ERM/NATS-IAA IRISH SEA ACP Pt1

**CAA DECISION LETTER**

**INTRODUCTION OF DUBLIN POINT MERGE - ADDITIONAL AIRSPACE  
REQUIREMENTS IN UK AIRSPACE**

**Dublin Point-Merge/L975**

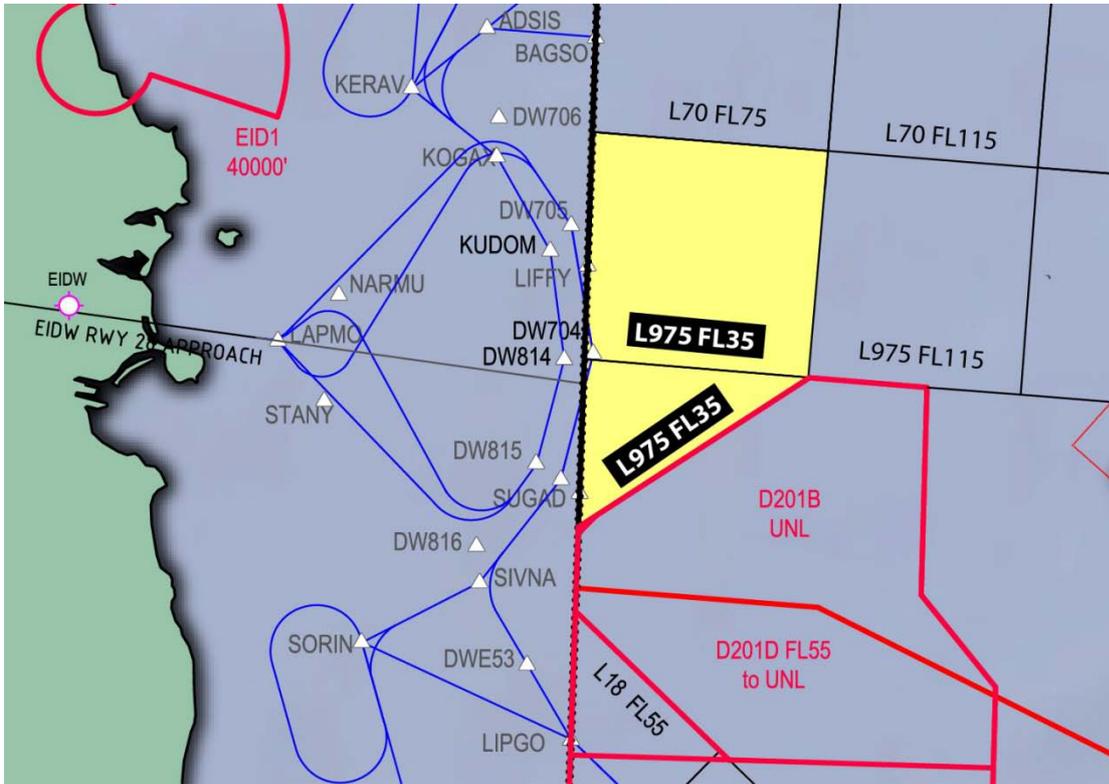
- 1.2 Point-Merge is a method of managing arrival streams by positioning aircraft on arcs rather than in holds. The chart at Enclosure 1 shows the proposed positioning of the PM arcs for Dublin westerly arrivals onto sequencing legs, for runway 28, denoted by the blue curved lines. The objective of this particular proposal is to provide controlled airspace for the PM sequencing legs without over-complicating the airspace structure. This additional CAS will be achieved

by lowering the existing base of L975 from flight level FL75 (approx 7500 feet) to flight level FL35 (approx 3500 feet), denoted by the yellow areas.

- 8.2 I have therefore decided to approve the revised UK airspace requirements to support the introduction of the IAA's Dublin Point Merge. The revised airspace will become effective from 13 December 2012. My staff will review the effectiveness of the arrangements not before 12 months after introduction and the results of this review will be published.
